Ute Mountain Ute Tribe

Re: Public Comment on
Amendment Radioactive Materials License No. UT 1900479
Amendment of the Groundwater Quality Discharge Permit No. UGW370004
Energy Fuels Resources (USA), Inc., White Mesa Uranium Mill, San Juan County, Utah

Ute Mountain Ute Tribe Response to EFRI Sur Reply Comments

(EFRI, 2020c)

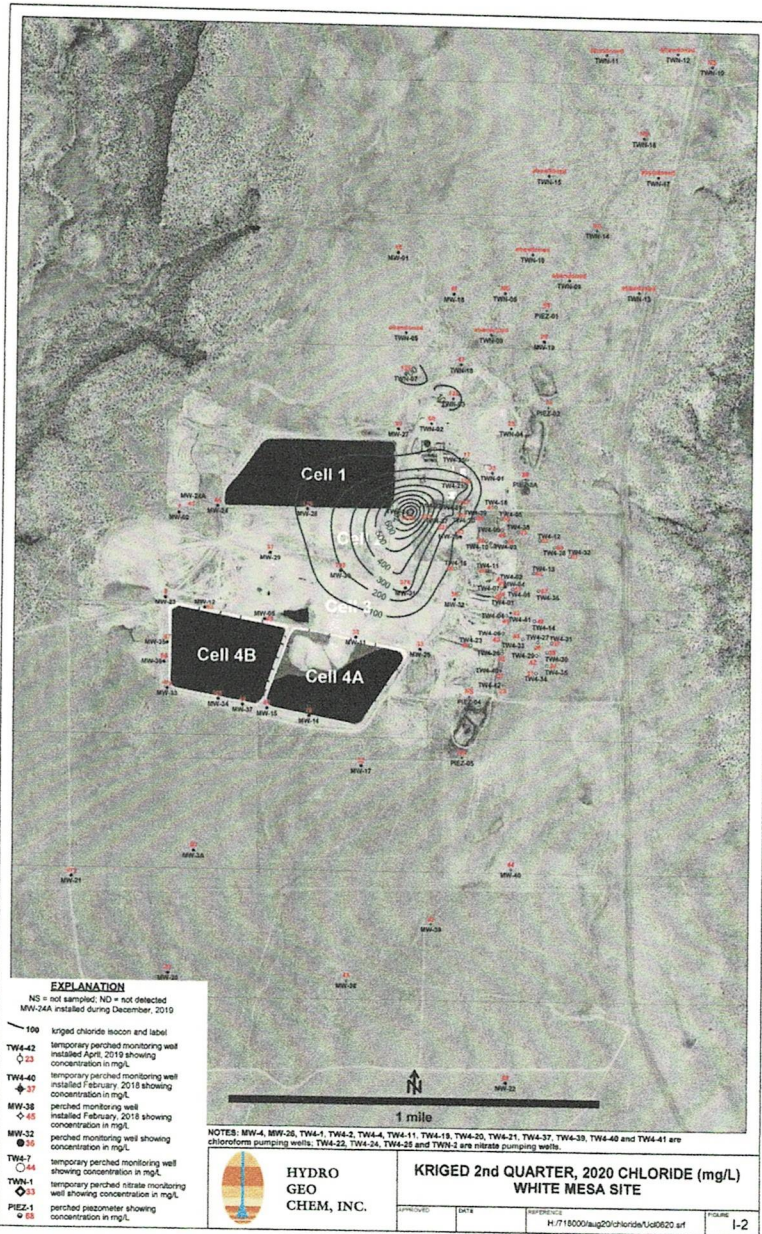
The source of the chloride plume is not migrating from a far upgradient location, the source is clearly centered near the SE corner of Tailings Cell 1 as the data from TW4-24 and other nearby wells show and the chloride concentration map from the second quarter 2020 nitrate groundwater report illustrates:
